**Economic and Social Council**Distr.: General
25 September 2012

Economic Commission for Europe**Inland Transport Committee****World Forum for Harmonization of Vehicle Regulations****Working Party on Passive Safety****Fifty-second session**

Hydrogen and fuel cell vehicles**Revised Draft global technical regulation (gtr) on hydrogen and fuel cell vehicles****Submitted by the experts of Japan, Germany and the United States of America***

The text reproduced below was prepared by the GRSP working group on Hydrogen and Fuel Cell Vehicles - Subgroup safety (HFCV-SGS) following the discussion on the proposal of a UN Global Technical Regulation (UN GTR) on safety of hydrogen and fuel cell vehicles. It is based on a document without symbol (GRSP-51-21-Rev.1) amending ECE/TRANS/WP.29/GRSP/2012/12 superseding ECE/TRANS/WP.29/GRSP/2011/33, distributed during the fifty-first session of the Working Party on Passive Safety (GRSP) (see ECE/TRANS/WP.29/GRSP/51, para. 19). The modifications to the current text of the draft UN GTR (ECE/TRANS/WP.29/GRSP/2012/12) are marked in bold for new or strikethrough for deleted characters.

Figure 7
Temperature profile of fire test

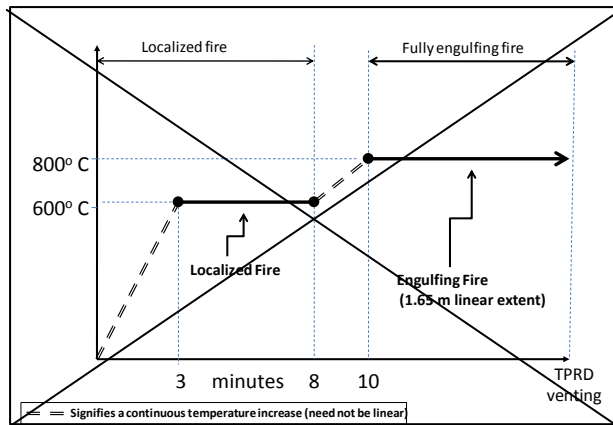
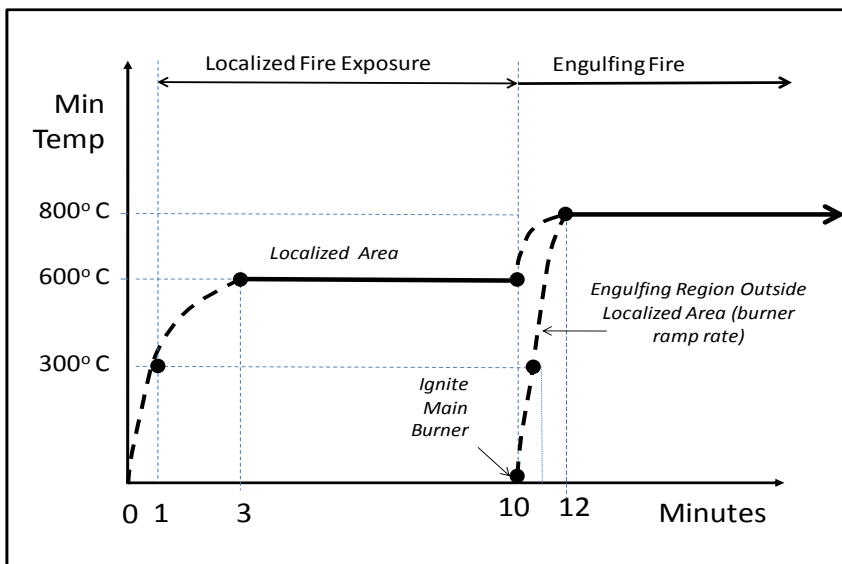
- (f) As shown in Figure 7 the temperature of the thermocouples in the localized fire area has increased continuously to at least **300 °C within 1 minute of ignition, to at least 600 °C within 3 minutes of ignition**, and a temperature of at least 600 °C is maintained for the next 7 minutes. The temperature in the localized fire area shall not exceed 900 °C during this period. Compliance to the thermal requirements begins 1 minute after entering the period with minimum and maximum limits and is based on a 1-minute rolling average of each thermocouple in the region of interest. (Note: The temperature outside the region of the initial fire source is not specified during these initial **8 & 10** minutes from the time of ignition.)

[The below profiles for fire time are being considered by SGS group:
